UNITED STATES
NUCLEAR REGULATORY COMMISSION
WASHINGTON, D.C. 20555-0001

SUBJECT: SHEARON HARRIS NUCLEAR POWER PLANT, UNIT 1 – CORRECTION TO
ISSUANCE OF AMENDMENT NO. 139 RE: MEASUREMENT UNCERTAINTY
RECAPTURE POWER UPRATE (TAC NO. ME6169)

By letter dated June 5, 2012,⁴ the licensee indicated that administrative errors in information submitted in support of Amendment No. 139 were reflected in the contents of TS page 2-2 and page 67 of the May 30, 2012, NRC safety evaluation (SE). Subsequently transcription errors were also identified on page 67 of the SE.

FIGURE 2.1-1
 REACTOR CORE SAFETY LIMITS – THREE LOOPS IN OPERATION
 WITH MEASURED RCS FLOW > [293,540 GPM X (1.0 + C₁)]

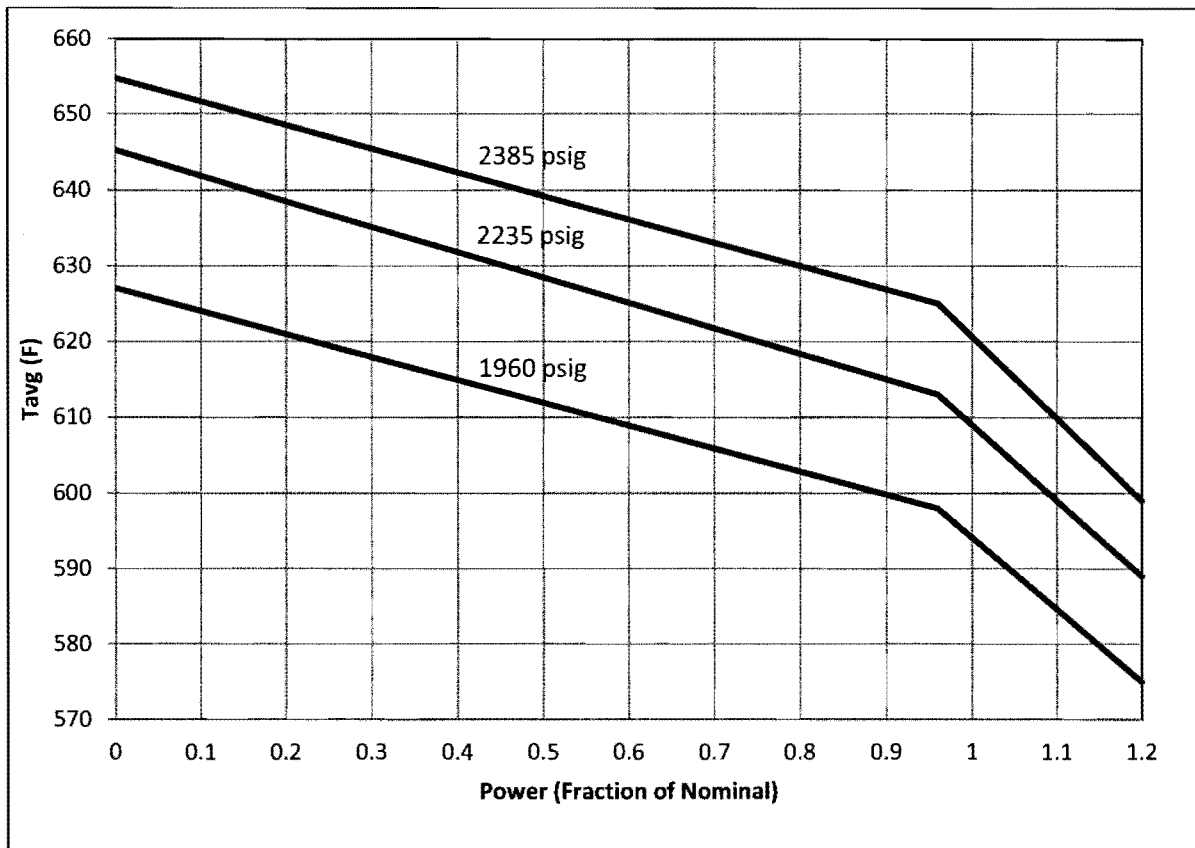
Currently the title of Figure 2.1-1 on TS page 2-2 reads: *REACTOR CORE SAFETY LIMITS - THREE LOOPS IN OPERATION WITH MEASURED RCS FLOW $\geq [293,540 \text{ GPM} \times (1.0 + C1)]$* . It should read ">" (greater than) instead of " \geq " (greater than or equal to).

Table 6, "Technical Specification Figure 2.1-1" of page 67 of the SE, incorrectly correlates the highest pressure data set to a value of 2375 pounds per square inch gauge (psig). Consistent

with Figure 2.1-1 on TS page 2-2, the correct value for that data set is 2385 psig.

Please replace TS page 2-2 for Renewed Facility Operating License No. NPF-63 and page 67 of the May 30, 2012, SE issued with the enclosed corrected pages. These administrative errors did not impact the NRC staff conclusions related to Amendment No. 139 for HNP because the NRC staff's review was based on the correct values for TS page 2-2 and page 67 of the SE.
